SERVICE INFORMATION BULLETIN

Subject: ADDITION OF SENSOR COVER FOR J08E ENGINE

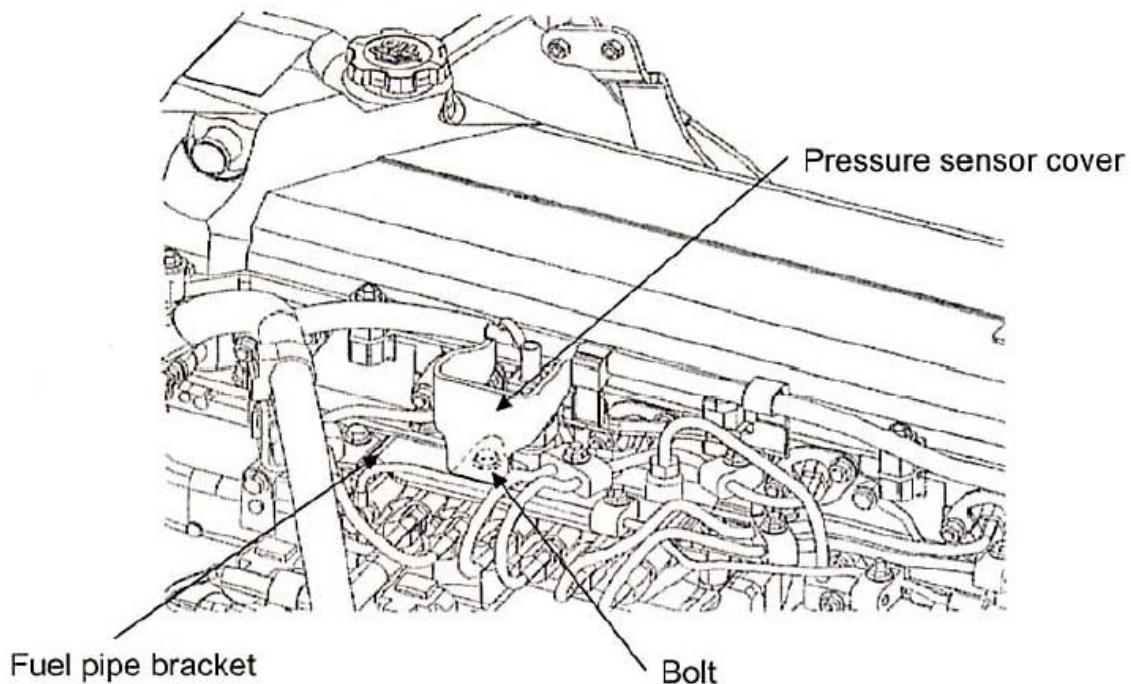
This document is to inform the dealers about the addition of the pressure sensor cover and related part for the J08E engine.

- a) Addition of the pressure sensor cover.
 - b) Addition of the pressure sensor cover mounting bolt on the fuel pipe bracket.
- (Please see page 2 of this bulletin for the illustration of the fuel pipe bracket change)
